NORTHEAST UTILITIES

November 4, 1982
Docket No. 50-336
A02724

Millstone Nuclear Power Station, Unit No. 2
Additional Information, Measurement Uncertainties

FIGURE 1

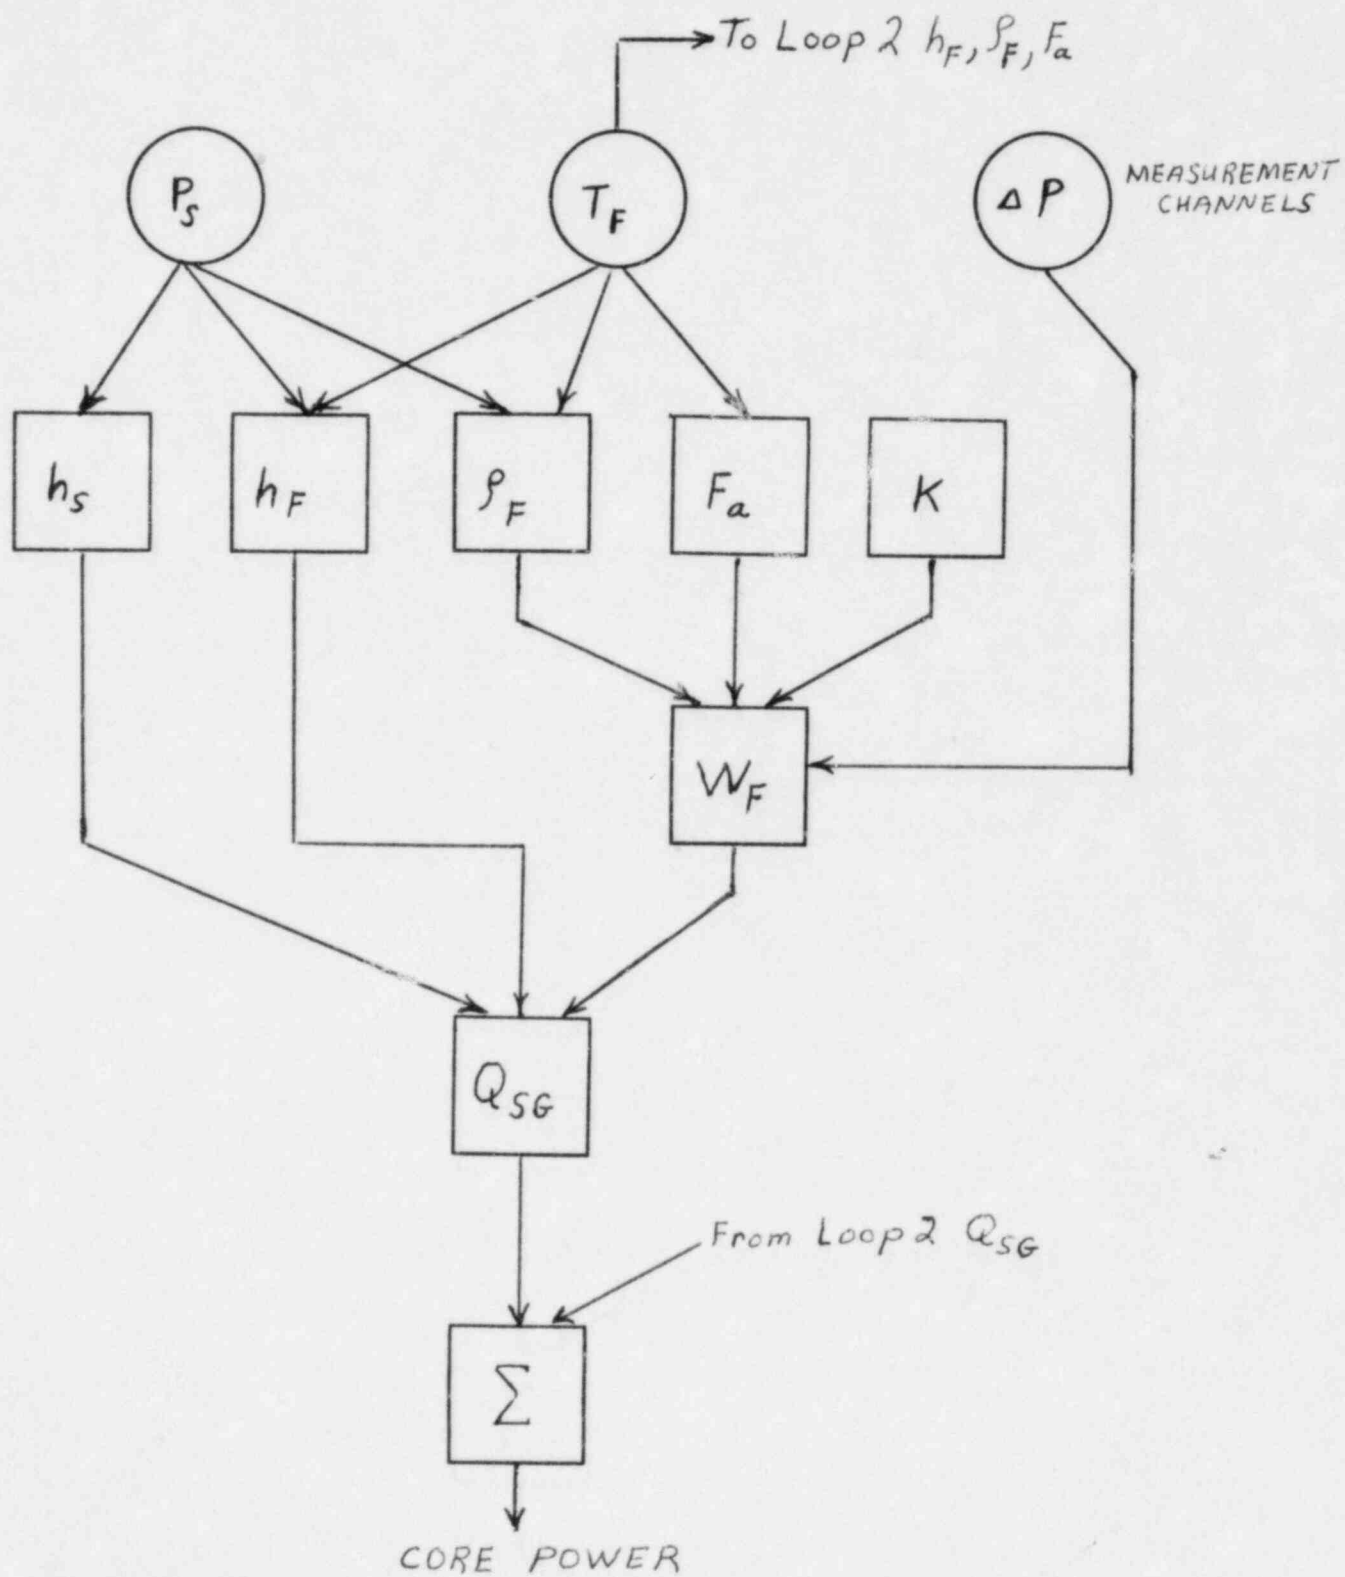
In some cases in your response, uncertainties which are not independent have been combined through the RMS technique. The RMS technique requires that the uncertainty contributions be independent. If they are dependent, their combined effect should be assessed through deterministic methods.

Three cases so identified are the feedwater venturi area expansion factor, feedwater density and feedwater enthalpy. These three factors are each dependent upon the feedwater temperature and are used in determining the core thermal power. Similarly, the feedwater density and steam enthalpy are both dependent upon steam generator pressure and are used in determining the core thermal power.

Correctly combine these dependent uncertainties deterministically to find if the uncertainty in the core power falls within the value used in the safety analyses.

Figure 1 provides a diagram of the measurements and calculations required to determine calorimetric core power. From Figure 1, it is seen that within each steam generator loop the steam enthalpy, h_s , feedwater enthalpy, h_f , and feedwater density, ρ_f , are dependent on the same measurement of steam generator pressure, P_s . Similarly, within each steam generator loop, feedwater enthalpy, h_f , feedwater density, ρ_f , and feedwater venturi area expansion factor, F_a , are dependent on the same measurement of feedwater temperature, T_f . The feedwater temperature measurement, T_f , also provides input to the Loop 2 h_f , ρ_f , and F_a calculations; therefore, the T_f error contributions are not only dependent within a single steam generator loop but also between each steam generator loop. The error contributions that are independent within each steam generator loop are the errors associated with the venturi calibration coefficient, K , the venturi ΔP measurement, and the component of the venturi area expansion factor, F_a , associated with the uncertainty in the linear thermal expansion coefficient.

Within each loop, steam and feedwater enthalpy and feedwater density are dependent on the same steam generator pressure measurement, P_s . However, since each steam generator loop has an independent pressure measurement, the overall enthalpy and density errors associated with steam generator pressure measurement errors are independent between loops.

Within each loop, feedwater enthalpy and density and the venturi area expansion factor, F_a , are dependent on the same feedwater measurement, T_f . Since the same feedwater temperature measurement is utilized for both loops, the T_f error contributions are not only dependent within a loop but also between each steam generator loop.
